IC6
Island Gwawis
VICTORIA
Move ramp 1.0m to approx. this location. Leaves 1.75m clearance to end of dock.
Move cleat 1.0m to here
Extend ramp platform 0.5m
Extend ramp platform 0.5m

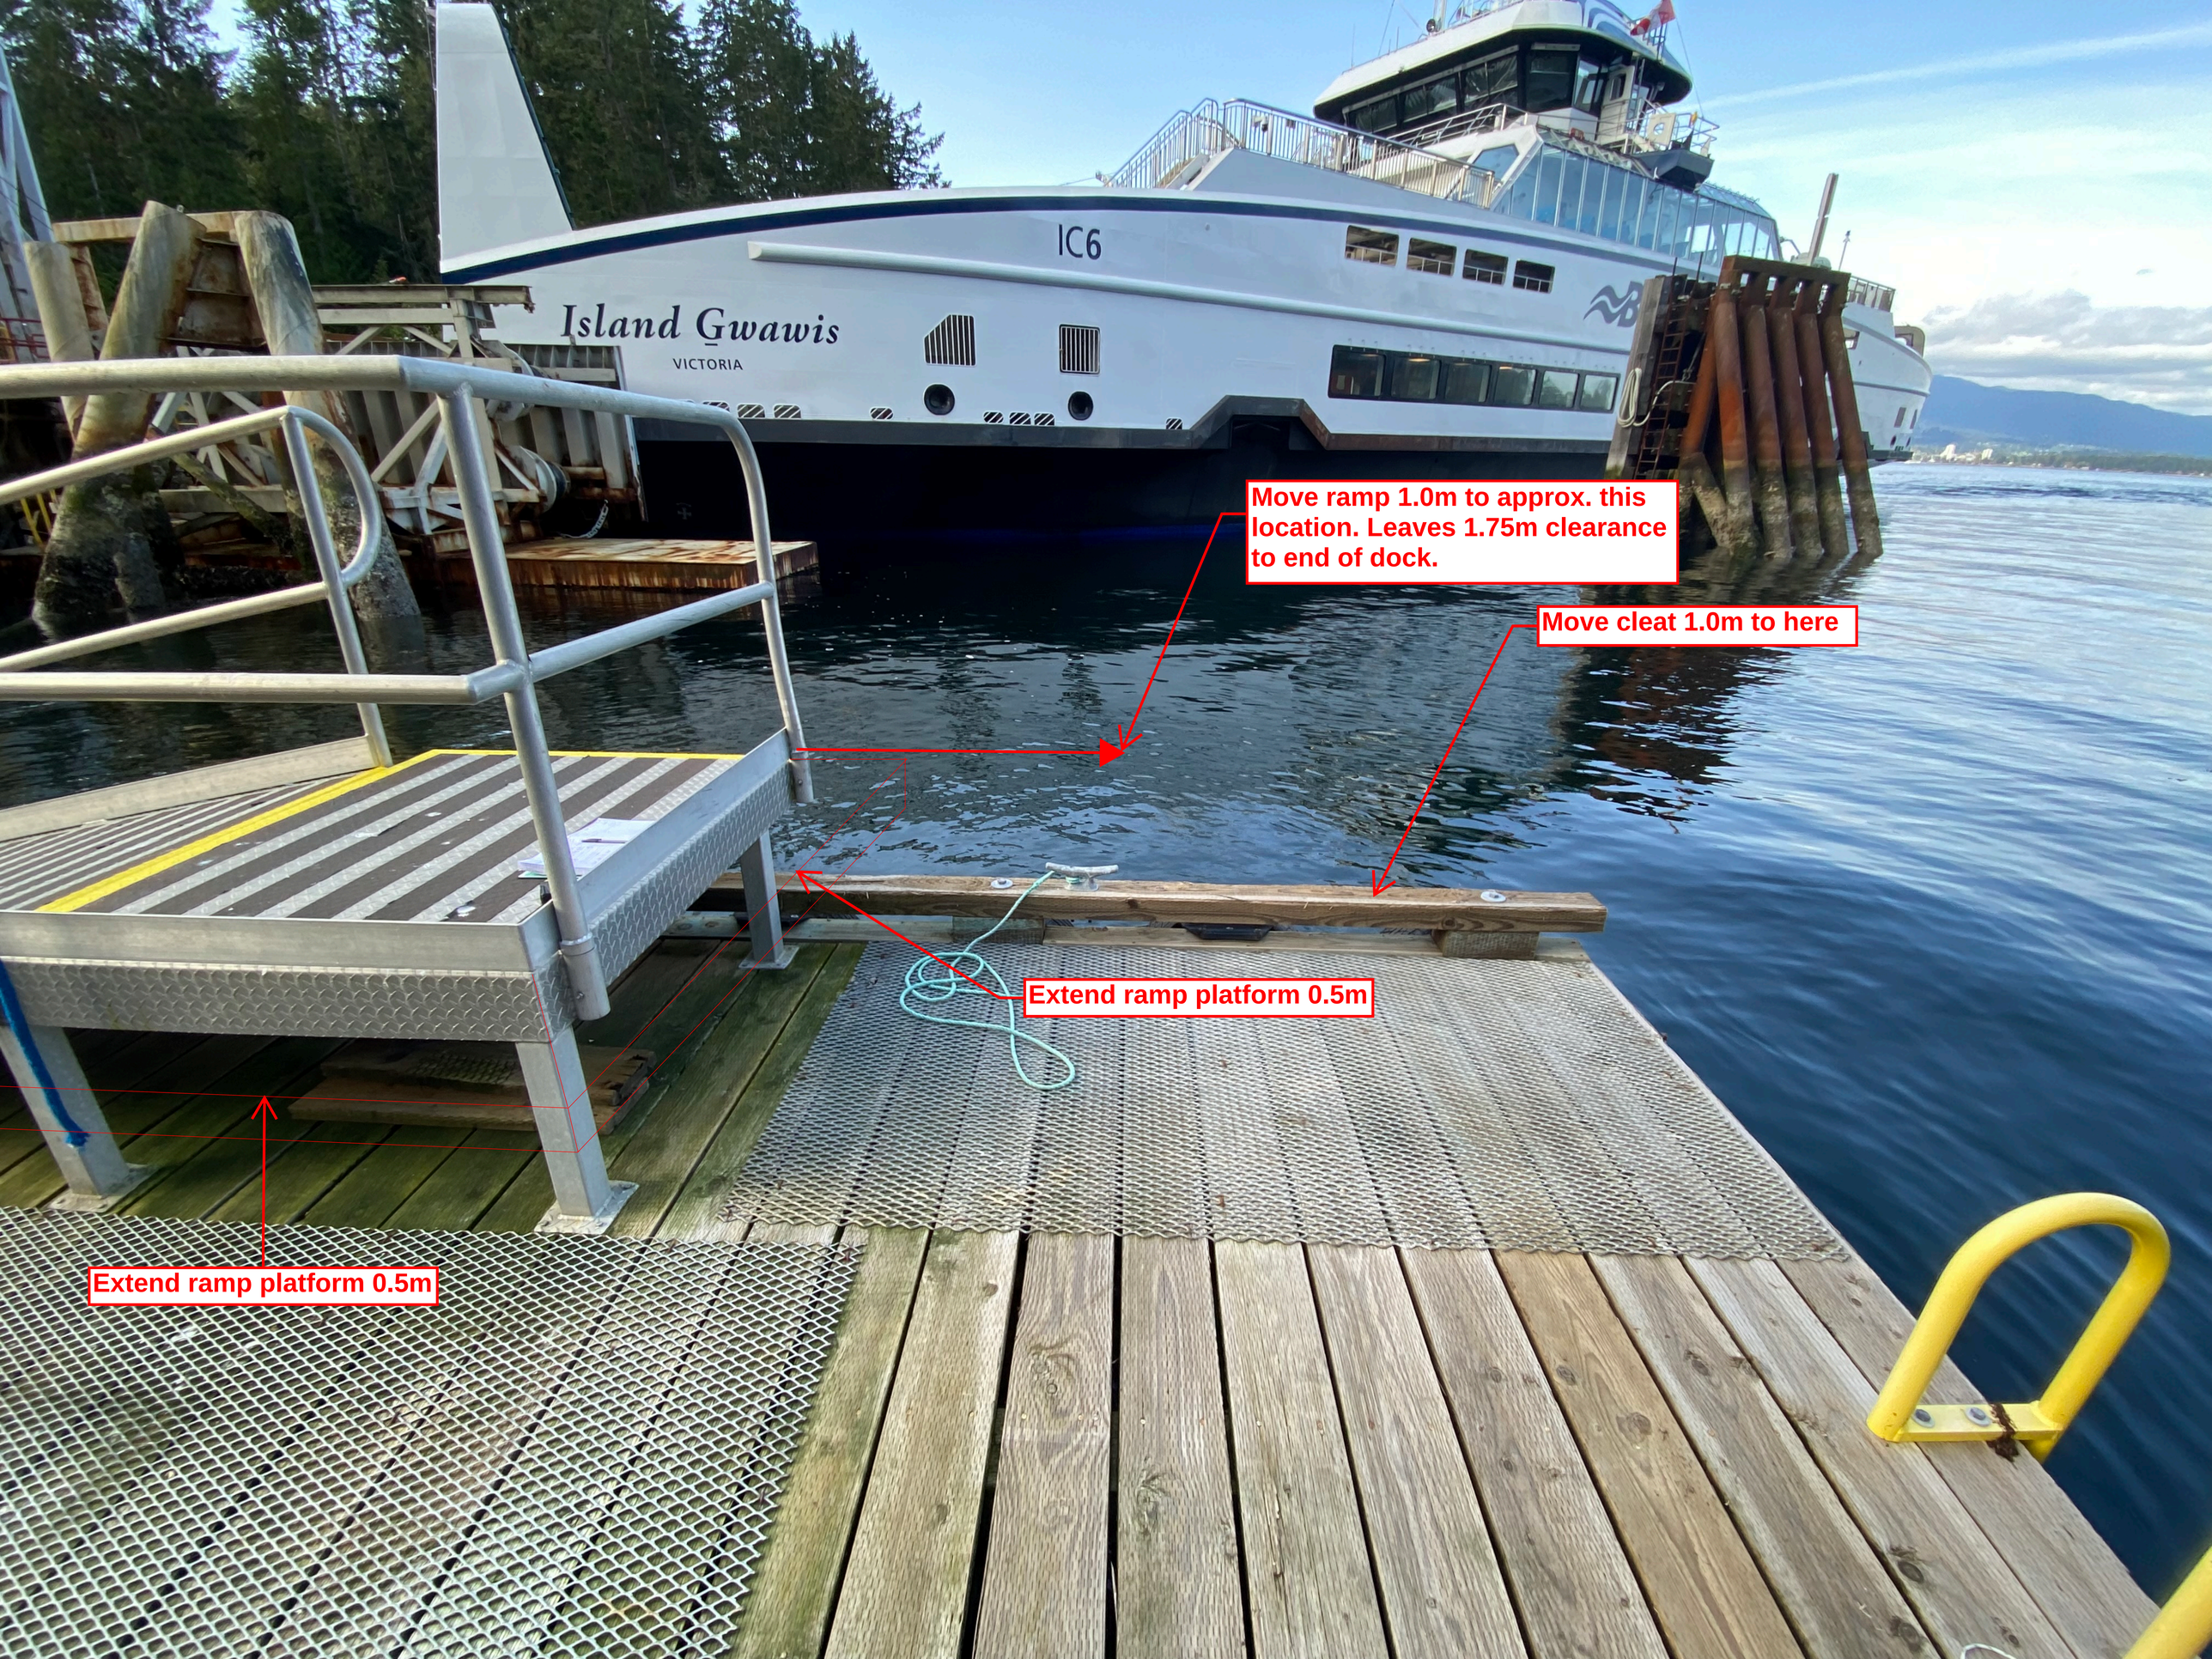
EMERGENCY SERVICE USE ONLY
NO PUBLIC DOCKING
1.0m clearance currently. Will be maintained by moving ramp 1.0m toward end of dock.
